CITY OF ALBUQUERQUE

**RE: North Domingo Baca Aquatic Center
Grading & Drainage Plans
Engineer's Stamp Date: 09/18/23
Hydrology File: C19D043E**

Based upon the information provided in your submittal received 11/14/2023, the Grading & Drainage Plans **are not** approved for Building Permit and Grading Permit. The following comments need to be addressed for approval of the above referenced project:

A1 DRAINAGE PLAN
1"=50'-0"

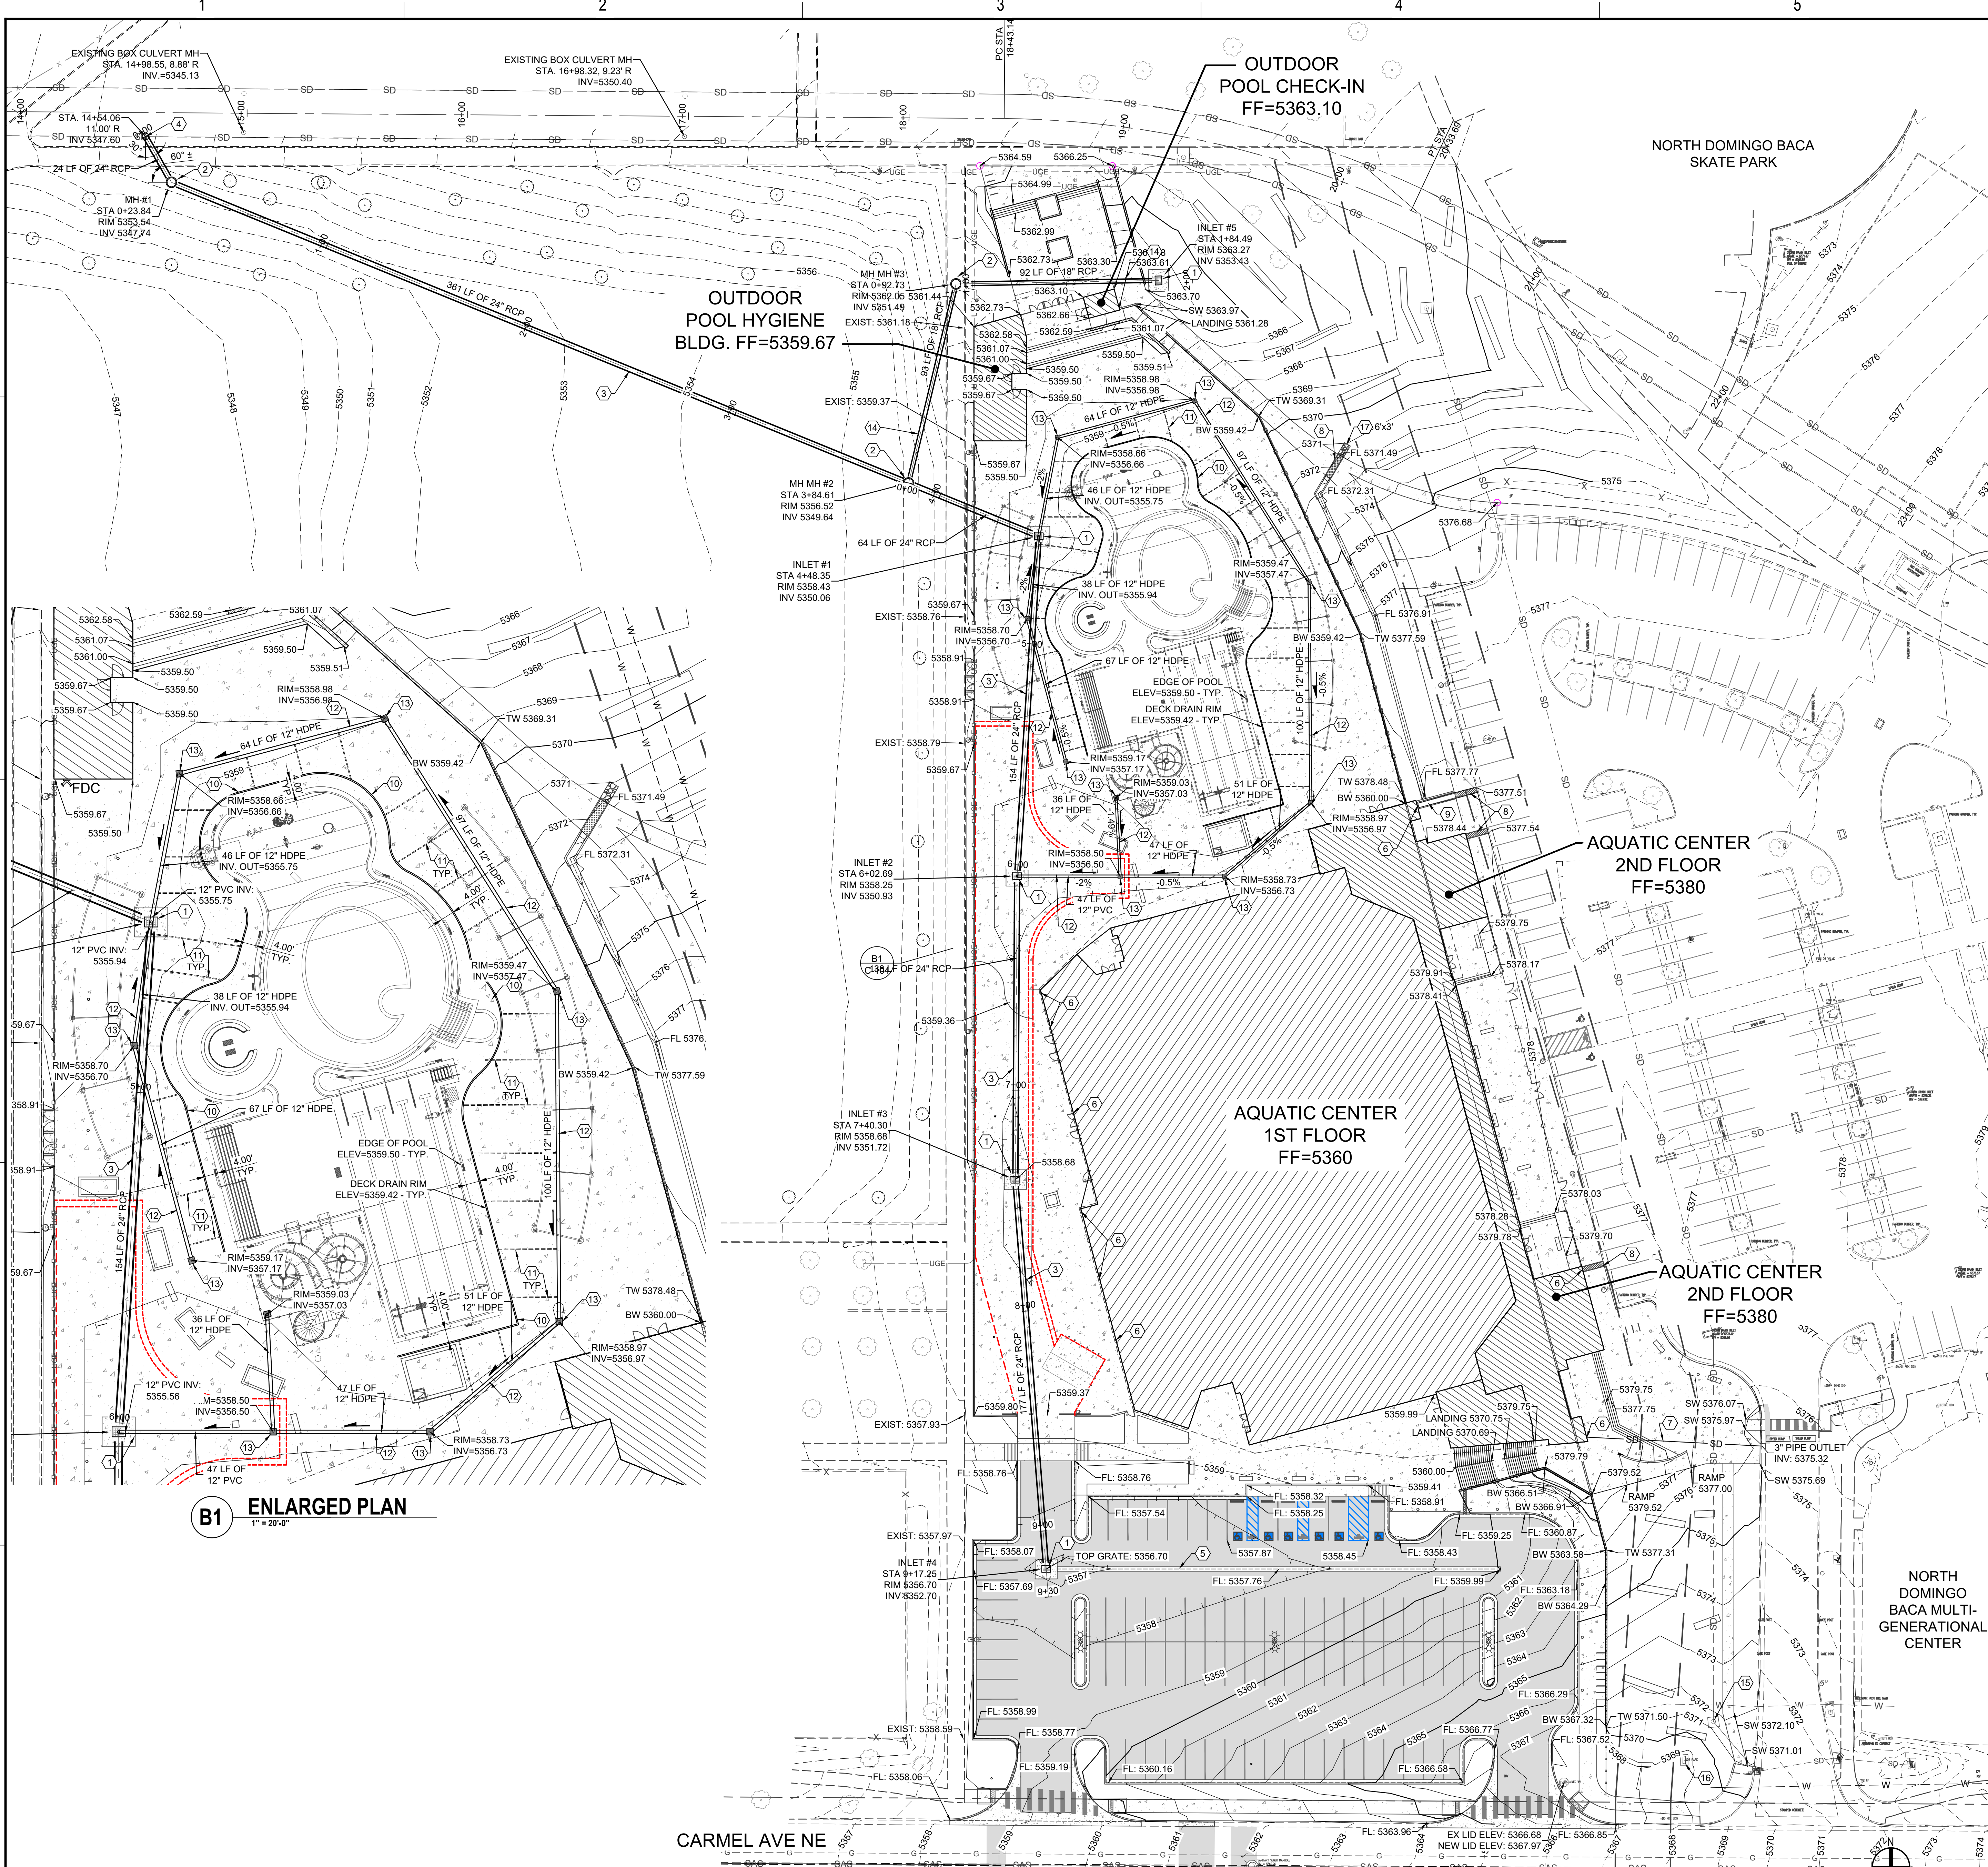
1. Since this project is adjacent to, or drains into an Albuquerque Metropolitan Arroyo and Flood Control Authority (AMAFCA) facility, approval by AMAFCA will be needed prior to Hydrology approval. Please contact Jared Romero P.E, CFM (jromero@amafca.org or 505-884-2215).
2. **Drainage Plan – C110.** Under the Existing Conditions, please add the existing discharge rate.

3. **Drainage Plan – C110.** Under the Flood Zone, it states that the flood zone is AO with a 1' depth inundation. Then it states that the Base Flood Elevation is 5320. How was this determined? North Domingo Baca is about elevation 5388 at the eastern property line along Wyoming Blvd and about 5332 at the western property line.
4. **Drainage Plan – C110.** Under the Proposed Conditions, please state that a LOMR will be submitted to FEMA to remove the flood zone AO from the property prior to Permanent Certificate of Occupancy.

- The Flood Zone section states that the BFE is 5320' for the AO1 flood zone. Where was this BFE derived? The site is largely at an elevation of ~5360. Verify or revise the BFE.
- Provide the hydrology calculations for the existing and proposed basins.
 - The proposed basins should be divided based on the proposed drainage infrastructure to ensure that the infrastructure is sized appropriately.
- Provide the hydraulic calculations for the proposed storm drain infrastructure on-site (inlet sizing, storm drain, etc.).
- Verify that there is capacity in the existing CBC for an additional pipe penetration.
 - The storm drain calculations should assume the max HGL in the CBC as the tailwater condition for the system.
